ORD Airport -Proposed Concessions F&B Package Questions & Answers

Updated: 1/20/2025

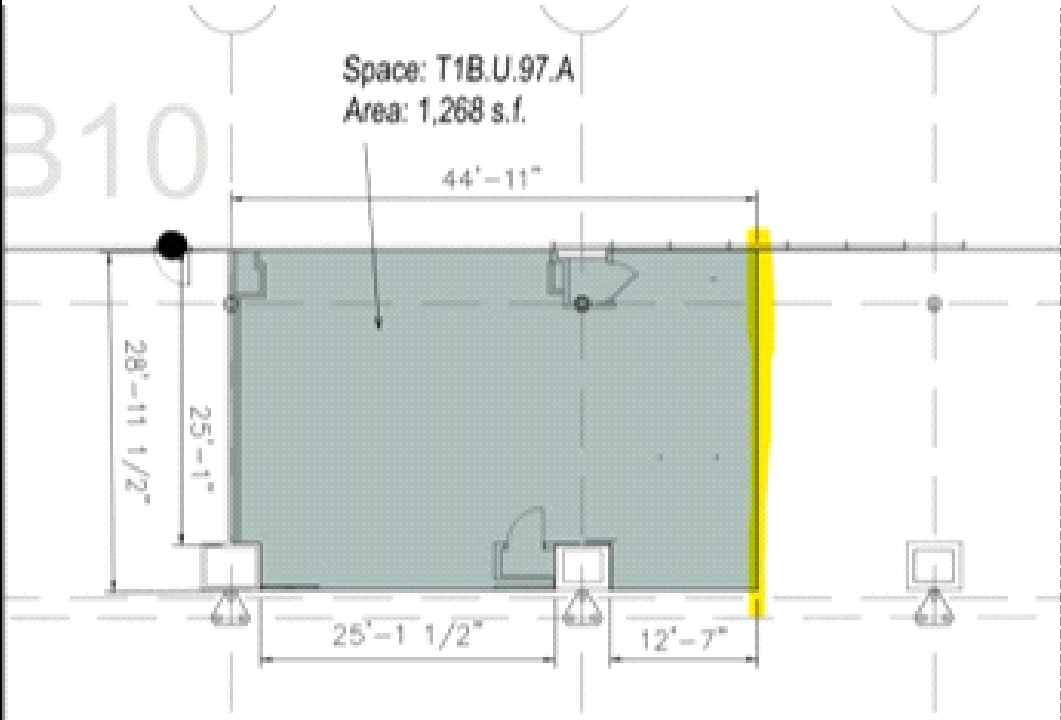
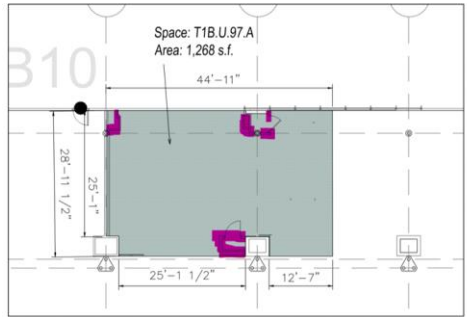
Space ID	Number	Questions	Question Reference	Answers
Terminal 1				
T1C.U.37.A	1	Please confirm whether the highlighted elements contain structural components and if they are approved for demolition or are to remain as existing. If they are to remain, could you confirm if the tenant is permitted to apply branding or finishes to these elements?	 <p>Space: T1C.U.37.A Area: 1,802 s.f.</p> <p>Spill out zone Space: T1C.U.37.A Area: 538 s.f.</p>	The Architect of Record & Tenant will be responsible for verifying the highlighted element in the field. However, the highlighted element does not appear to be a structural component. The extent of development, including demolition and branding, is acceptable within the boundaries defined by the LOD. The CDA will review all design decisions during the design review process.
T1C.U.37.A	2	Please confirm is there is an existing wall on the highlighted below. Can you please confirm if we can leave this open as show on the LOD ?	 <p>Space: T1C.U.37.A Area: 1,802 s.f.</p> <p>Spill out zone Space: T1C.U.37.A Area: 538 s.f.</p>	Please reference Addendum #5

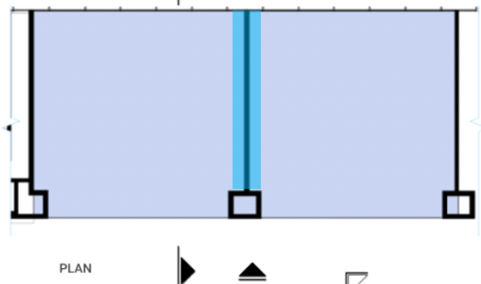
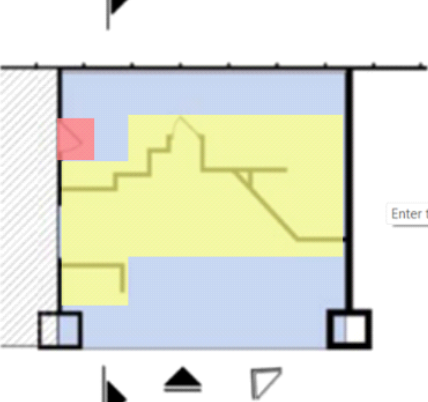
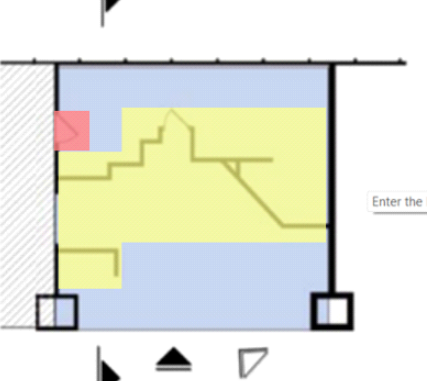
T1B.U.76.A	9	Right side of the space indicates some sort of furring/chase on the right side of the space. please advise if this condition is to remain - it is not shown in the tenant design guideline drawings		The Architect of Record & Tenant will be responsible for verifying the highlighted element in the field. The extent of development including demolition may be applied within the boundaries defined by the LOD. The CDA will review all design decisions during the design review process.
T1B.U.76.A	10	Drawings identify the right side of the space being completely walled off from the rest of the space - can this partition be demolished entirely or are we restricted to the amount of demo we can do?	 <p>Space: T1B.U.76.A Total: 2,719 s.f.</p> <p>95'-2"</p> <p>39'-10"</p> <p>25'-0"</p> <p>21'-62"</p> <p>B</p>	The Architect of Record & Tenant will be responsible for verifying the highlighted element in the field. he extent of development including demolition may be applied within the LOD. The CDA will review all design decisions during the design review process.

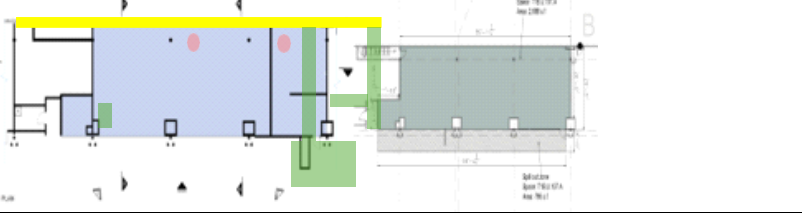
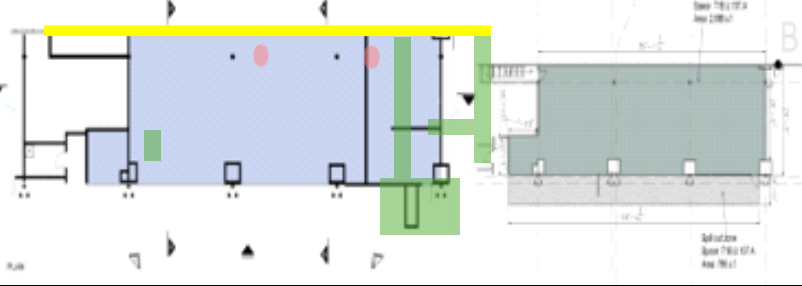
T1B.U.76.A	13	Please confirm whether the highlighted columns are included in this space's LOD and if branding or materials can be applied. Additionally, please confirm if any access panels or systems need to be considered in the proposed design		The Architect of Record & Tenant will be responsible for verifying the highlighted element in the field. The extent of development including branding is acceptable within the boundaries defined by the LOD. The CDA will review all design decisions during the design review process.
T1B.U.76.A	14	Existing tenant provided a signage outside of LOD shown. Is it permitted to incorporate a similar signage on the base build column outside of the LOD similar to the existing tenant?		The CDA will review all design decisions during the design review process. Any design should adhere to the O'Hare Concessionaire Design Guidelines.
T1B.U.76.A	15	Is there gas available for this tenant?		No gas is available at Terminal 1.

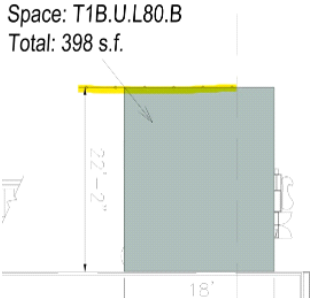
T1B.L85.H	20	Doors shown do not appear to be associated with a wall. Please advise if there is an existing wall to remain, if the doors are electrical panels etc.		The Architect of Record & Tenant will be responsible for verifying the highlighted element in the field. It appears to contain a recessed electrical panel and a recessed fridge. The existing concession has an accessible back wall that falls within the boundaries of the LOD. The extent of development is acceptable within the boundaries defined by LOD. The CDA will review all design decisions during the design review process.

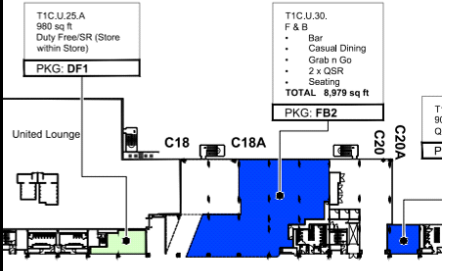
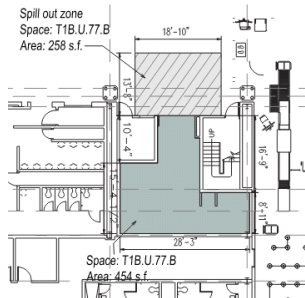
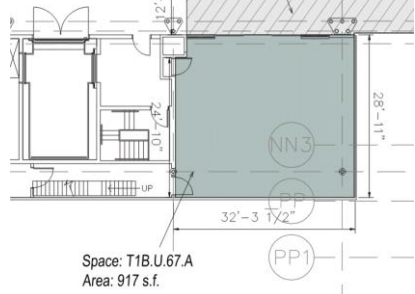
Space ID	Number	Questions	Question Reference	Answers
T1B.U.97.A	24	Please confirm what the blue highlighted item is in plan and if it can be demolished:		The Architect of Record & Tenant will be responsible for verifying the highlighted element in the field. However, the wall appears to be an existing wall and may be demolished. The extent of development is acceptable within the boundaries defined by LOD. The CDA will review all design decisions during the design review process.
T1B.U.97.A	25	4. What is stored in this niche/closet? The small area is not within lease, if we demolish the door and walls, how will this wall be finished/ how will it look?		The Architect of Record & Tenant will be responsible for verifying the highlighted element in the field. However, it appears to be an existing closet for the current concessionaire. The extent of development is acceptable within the boundaries defined by LOD. The CDA will review all design decisions during the design review process.

T1B.U.97.A	26	There are small closets and/or chaises shown in the LOD that differ from the Design Guideline drawings. Please advise what these serve and if utility spaces that cannot be demolished.		The Architect of Record & Tenant will be responsible for verifying the highlighted element in the field. The extent of development is acceptable within the boundaries defined by LOD. The CDA will review all design decisions during the design review process.
T1B.U.97.A	27	Is there gas available for this tenant?		No gas is available at Terminal 1.
T1B.U.97.A	28	Is there direct access to the roof for equipment (such as exhaust fans, condensing units)?		The Architect of Record & Tenant will be responsible for verifying any field condition. Access to the roof is available.
T1B.U.97.A	29	Is there remote support storage available for this tenant?		Remote storage is limited and will be allocated based on availability, tenant occupancy requirements, and leased space.

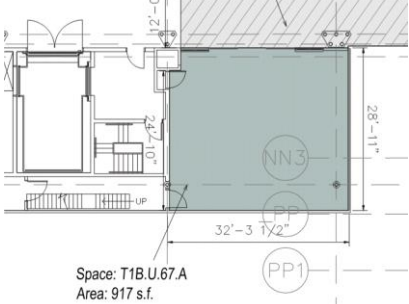
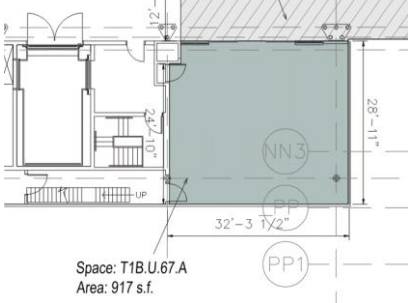
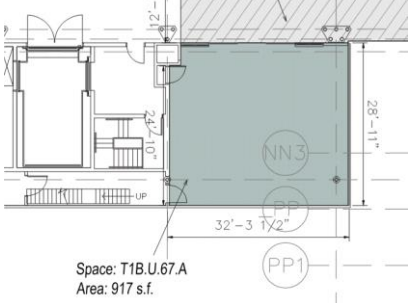
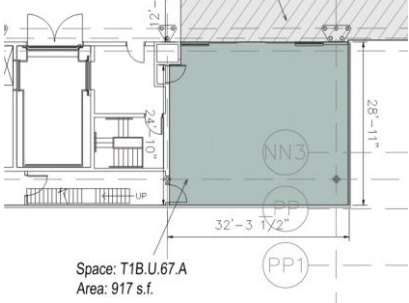
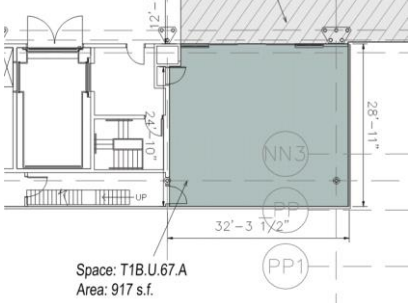
T1C.U.32.J	34	Are closure grilles required on Attached Kiosks? They are not shown on diagrams, but are mentioned on legends. Or can we do lockable fixtures instead?		Concessionaires are responsible for securing their own premises and ensuring compliance with TSA requirements. Please refer to Sheets 1-41-42 of the O'Hare Concessionaire Design Guidelines for acceptable and prohibited closure types.
T1C.U.33.B	35	Is the back of this LOD base build glazing or solid wall? TDC shows glazing and LOD pdf shows solid wall.		The back of this LOD is glazing. The exterior window must remain accessible for maintenance and cleaning. For concessionaire spaces with window views out to the airfield, CDA recommends that the back wall maintain at least 25% openness. Please refer to Concessionaire Design Guidelines page 1-39.
T1C.U.33.B	36	Are closure grilles required on Attached Kiosks? They are not shown on diagrams, but are mentioned on legends. Or can we do lockable fixtures instead?		Concessionaires are responsible for securing their own premises and ensuring compliance with TSA requirements. Please refer to Sheets 1-41-42 of the O'Hare Concessionaire Design Guidelines for acceptable and prohibited closure types.

Space ID	Number	Questions	Question Reference	Answers
T1C.U.33.B	37	Is there designated storage spaces between Attached Kiosks? Or what are the doors in between intended for?		Any on-site storage must fall within the LOD. 2. Doors shown are renderings only and optional and could function as storage or employee entrance.
T1C.U.10.A	38	Can the wall dividing the LOD highlighted in blue be demolished?		The Architect of Record & Tenant will be responsible for verifying the highlighted element in the field. The extent of development, including demolition, is acceptable within the boundaries defined by LOD. The CDA will review all design decisions during the design review process.
T1C.U.45.B	39	Can all walls highlighted yellow be demolished?		The walls within the highlighted yellow area appear to be the current kitchen walls and can be removed. The Architect of Record & Tenant will be responsible for verifying the highlighted element in the field. The extent of development, including demolition, is acceptable within the boundaries defined by LOD. The CDA will review all design decisions during the design review process.

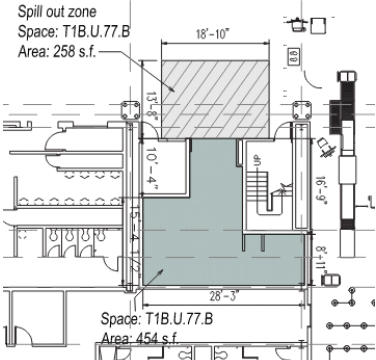
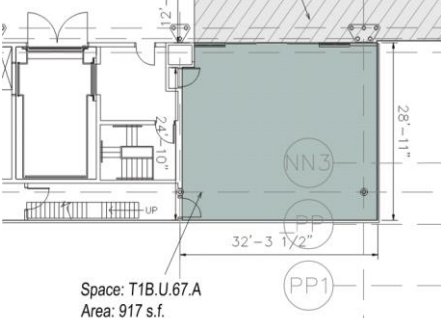
T1C.U.45.B	40	Does the door highlighted red lead to a service corridor? If not, what does it lead to?		The door is located in the existing concession area back-of-house (BOH) and leads to the FOH. The Architect of Record & Tenant will be responsible for verifying the highlighted element in the field. The extent of development, including demolition, is acceptable within the boundaries defined by LOD. The CDA will review all design decisions during the design review process.

Space ID	Number	Questions	Question Reference	Answers
T1B.U.107.A	41	Can the area highlighted in yellow be confirmed that it is windows? The existing space looks like there are images along the back.		The back wall contains windows. The Architect of Record & Tenant will be responsible for verifying the highlighted element in the field. The extent of development is acceptable within the boundaries defined by LOD. The CDA will review all design decisions during the design review process.
T1B.U.107.A	42	2. Are the circles highlighted in red base build columns?		Yes, those are columns. The Architect of Record & Tenant will be responsible for verifying the highlighted element in the field.
T1B.U.107.A	43	3. The LOD (right) we received and the TDC plan (left) show different elements highlighted in green. Please clarify if the elements highlighted in green can be demolished		The Architect of Record & Tenant will be responsible for verifying the highlighted element in the field. The extent of development, including demolition, appears to be acceptable within the boundaries defined by the LOD. The CDA will review all design decisions during the design review process.

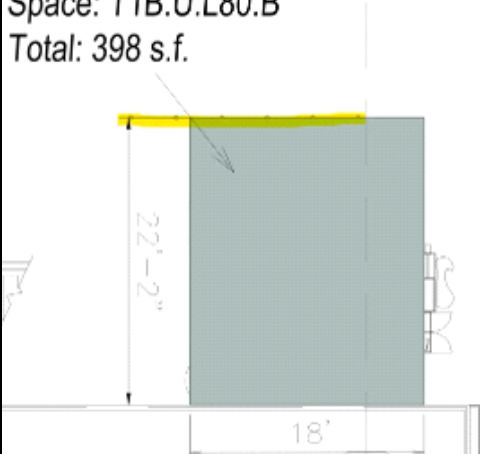
Space ID	Number	Questions	Question Reference	Answers
T1B.U.L80.B	48	1. Could you please confirm the nature of the structure highlighted in front of the lease line? Is it possible for this structure to be removed, or must it remain as part of the base building? (A portion of it is not within our lease area).	 <p>Space: T1B.U.L80.B Total: 398 s.f.</p>	The highlighted element appears to be a static wall for the current concession, and it may be demolished. The Architect of Record & Tenant will be responsible for verifying the highlighted element in the field. The CDA will review all design decisions during the design review process.
T1B.U.L80.B	49	Is there a centralized grease interceptor to tie into?		There is no centralized grease trap. Concessionaire must provide independent grease traps in the concessions space as required by the City of Chicago Code.
T1C.U.49.E	50	Please confirm if there is existing plumbing running to this space.		The Architect of Record & Tenant will be responsible for verifying any field condition. However, the current concessions appear to have existing plumbing.
